Subject: Pinnacle at Liberty Bay PRD and Preliminary Subdivision | P-06-20-25-03 | Request for Revisions

To: Montebanc Management LLC
From: Nikole Coleman, AICP, Planning Manager
Subject: Pinnacle at Liberty Bay PRD; Request for Revisions No. 2; P-06-20-25-03
Date: December 31, 2025, Revised January 9, 2026

RE: **PINNACLE AT LIBERTY BAY
THIRD-PARTY CRITICAL AREAS REVIEW
FARALLON PN: 3386-002.001 TASK 3**

Fig 1. Site potential tree height at project site.

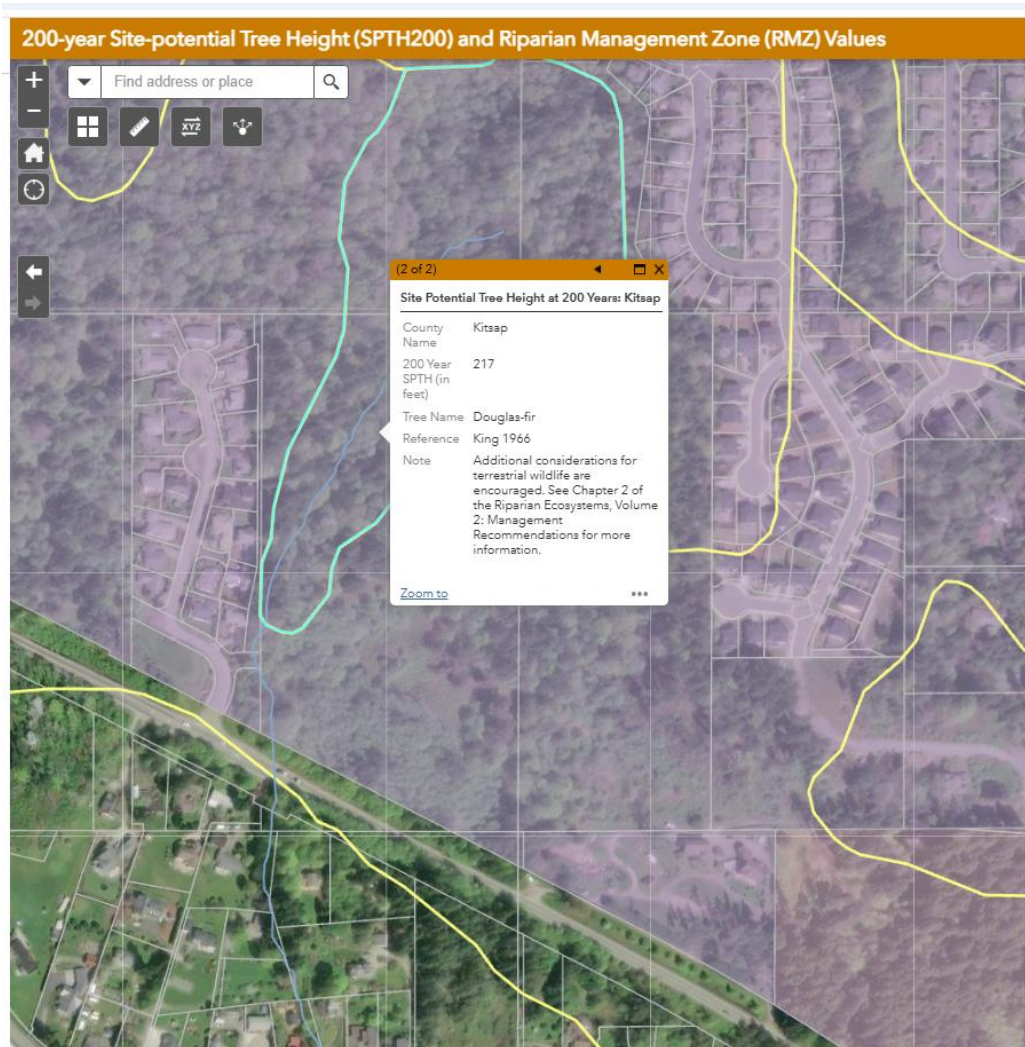
The applicant should not expect stream buffers less than the recommended minimum of 100 feet, will be sufficient to remove pollutants. Additionally, it should be assumed that any riparian buffer less than a SPTH is a *de facto* impact to the non-pollutant removal functions of the riparian area that should be considered during SEPA and other environmental review.

Fig 2. Location of mapped pocket estuary in relation to project site.

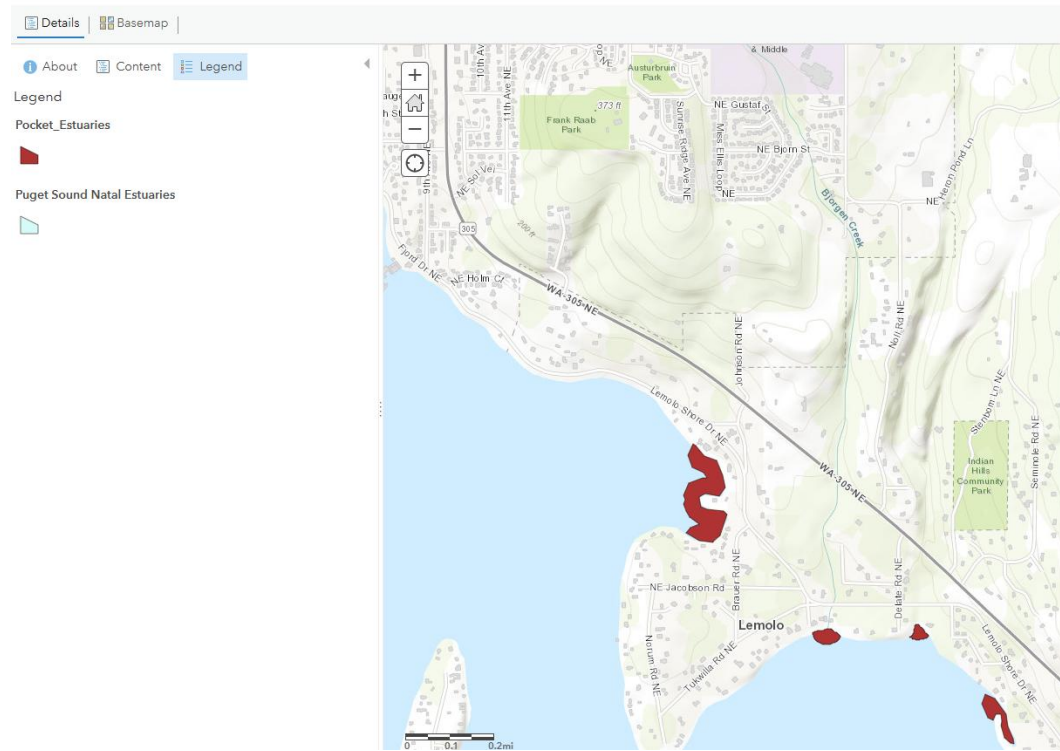
Furthermore, the marine area near where the streams traversing the project site discharge into Liberty Bay is mapped as a pocket estuary (Fig 2) and there are small deltas near the mouth of the Barrante’s Creek and stream D. As a result, considerable juvenile salmonid use, particularly coho and chinook, in this area is to be expected, increasing the probability some juveniles will
